DOCUMENT NUMBER: 17-00180
 ISSUE NUMBER: 2
 ISSUE DATE: March, '98

RELATED DOCUMENTS:
 C/R 25315
 17-00175

Transceiver fails to power up normally

Figure 1: Location of IC11

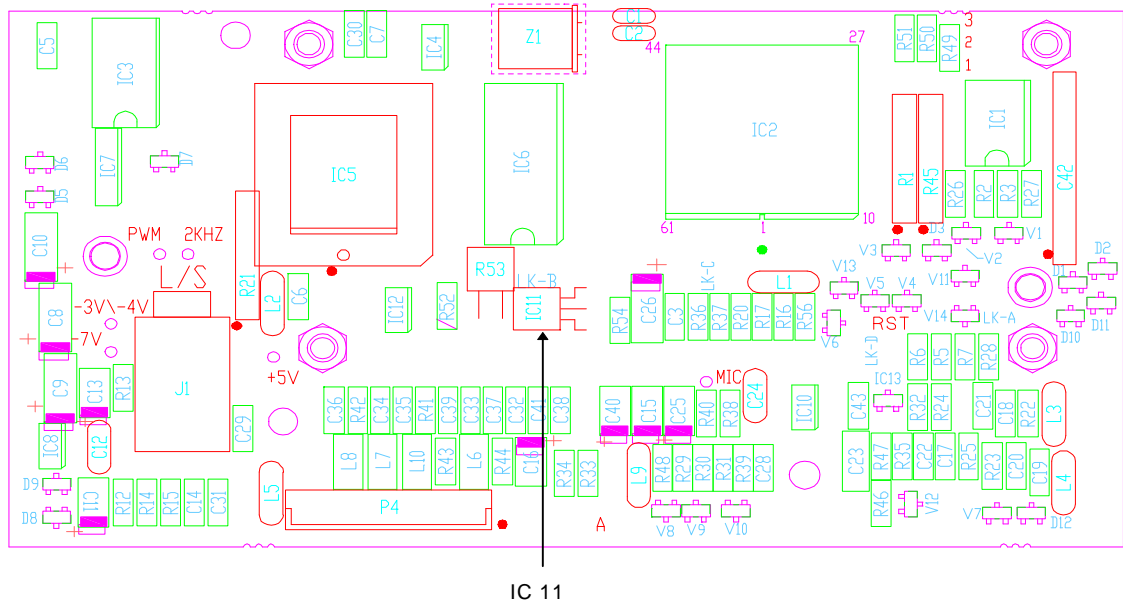
The problems are caused by the use of non brand-name, generic voltage regulators.

A recent change to the microprocessor reset circuit (refer Service Bulletin 17-00175), has made the use of non brand-name generic regulator types unacceptable.

- ❑ Locate IC11. Refer to Figure 1.

- ❑ Carefully lift IC11 up off the board so that the identifying markings on its flat side may be read.
- ❑ Check that the regulator has a manufacturer's marking such as a **trademark** or a **name**.
- ❑ If IC11 does not have a manufacturer's trademark or name it will need replacing. Continue at *Procedure: changing the regulator*.
Otherwise, continue at *Reassembly*.

- 1 x LM340LAZ-5.0 voltage regulator, Codan part number XB-07805-501

- ❑ Insert the regulator into the three holes. *Flat side down*. Refer to Figure 1.
- ❑ Solder the three leads into the display board.

Figure 2: Formation of regulator leads

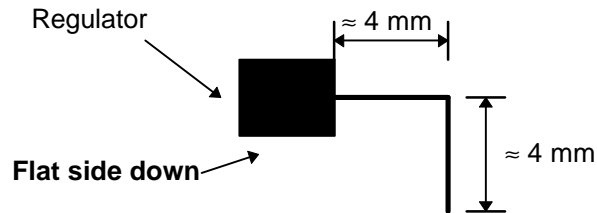
- ❑ Cut each of the three leads of the regulator as close as possible to the body of the regulator.
- ❑ Using the soldering iron and the pliers, heat each joint and remove the leads from the board.
- ❑ Using the desoldering tool or the desoldering wick, clear the solder from the three holes.
- ❑ Form and trim the leads of the replacement regulator. Refer to Figure 2.
